District of Columbia Government  
Advisory Neighborhood Commission 6A  
Box 75115  
Washington, DC 20013

Re: Opposition to shed; conditional support for fence - DDOT PSRA Permit # 3358240: at 205 15th Street NE

Figure 1. Survey, 205 15<sup>th</sup> Street, NE, Square 1068SE, lot 803, and parking.  
Proposed accessory building is not to scale.

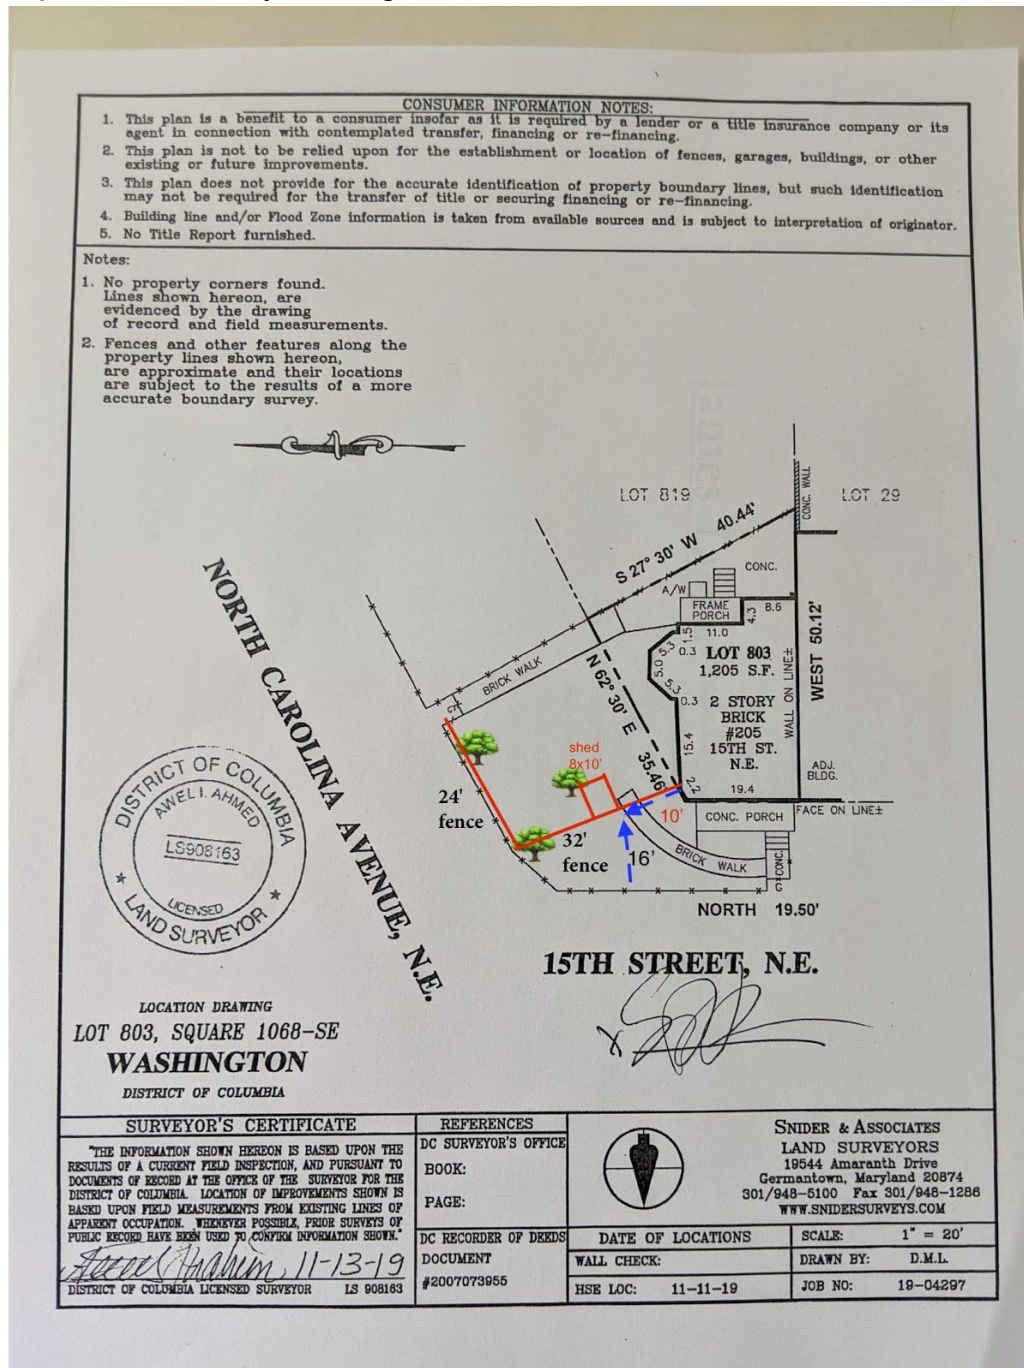
ANC 6A opposes the application of Sunny K. Petzinger, seeking permission to erect an accessory building (garden shed) in the public parking<sup>2</sup> adjacent to 205 15th Street NE. (See Figures 1, 2.) The dimensions of the proposed building are 8 x 10 feet, and, per Ms. Petzinger's statement, approximately 7 feet tall.

The law on parking (Parking Act of 1870), beginning in 1870 and continuing through the present, mandates that parking be preserved as open public space used for trees, greenery or parks. Per DDOT's Public Realm Design Manual, bay windows, oriel windows, corner towers, and porches to project into public space (if granted a public space permit) but there is no provision for separate accessory buildings. The proposed building would occupy and obstruct open space and, for this reason, the application should be denied.

1. An accessory building is not an architectural projection from an existing structure (such as a bay, porch or window well) and is therefore not included in the list of permissible exceptions.
2. Furthermore, the building would occupy a significant portion of the parking and would block the view of additional greenspace, undermining the goal of a visible park.
3. Finally, approval of this application would open the door to innumerable future similar structures which would further erode public parking, city-wide.

Figure 3. Comprehensive Plan Proposed Amendments, Urban Design Element, Locally Significant View Corridors. (2018)

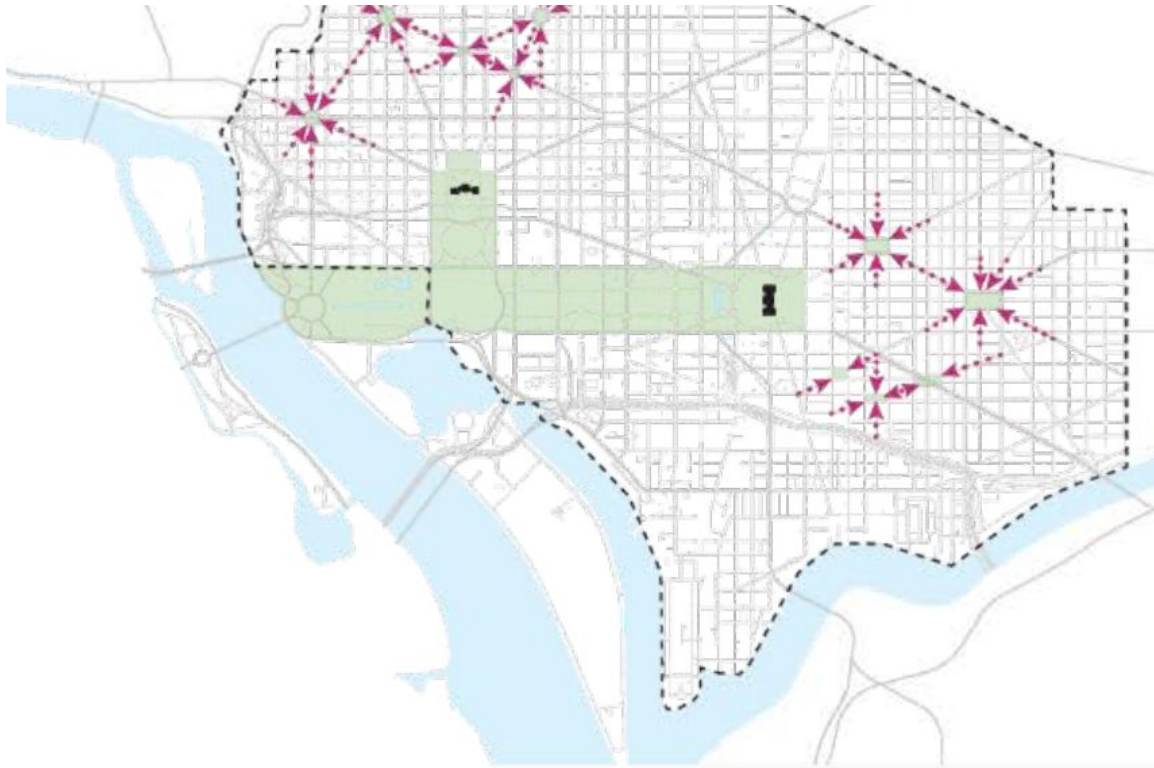
The Public Realm Design Manual, further cites the Comprehensive Plan's emphasis on view sheds. The Urban Design Element (2018) identifies North Carolina Avenue as a locally significant viewshed. (See Figure 3.) While the accessory building would not actually block the view, it would detract from the view in a highly visible and significantly undesirable way.
